16 July 2024

PTTPP RESIDENTIAL RE-ZONING AND WESTPORT RIFLE RANGE NOISE MODELLING WITH DETAILED TERRAIN DATA

Figure 1: Shooting noise contours overlaying the Alma Road subdivision (General Residential Zone)

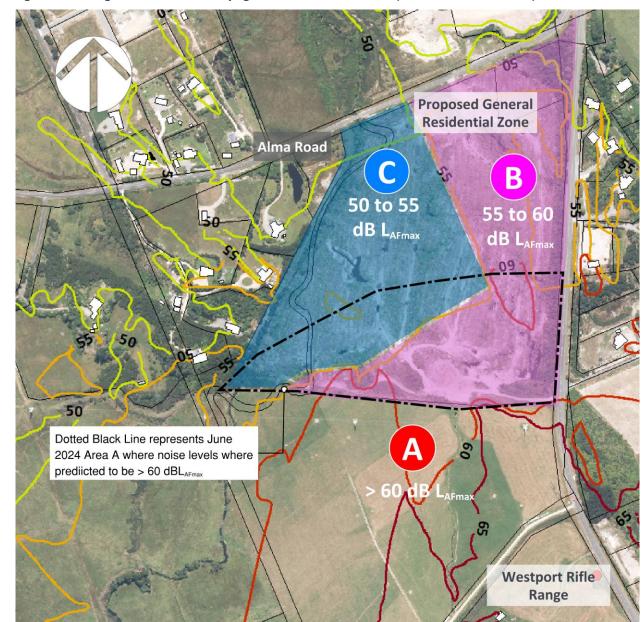
- Detailed modelling using rifle range noise levels and publicly available terrain data¹ indicates there are no significant areas of the proposed General Residential Zone with noise levels greater than 60 dB L_{AFmax}. This is shown in Figure 1. In the context of proposed TTPP rules, we interpret the contours as meaning there are no areas within this block of land where residential development should be discouraged. This advice differs from the preliminary modelling presented in our June letter.

- 2. Approximately half the block south of Alma Road, to the south and east, has a noise level above 55 dB L_{AFmax} (Area B in Figure 1). We agree with Mr Barr that amendments to Rule Noise-R3 would permit residents to manage noise effects in living areas both inside and outside the dwelling.

- 3. No mitigation is required between 50 and 55 dB L_{AFmax} (Area C in Figure 1).
- 4. In Figure 1, we have overlayed the noise from the rifle range's irregular shaped noise contours with simplified areas (A, B and C) that represent areas of similar noise exposure.
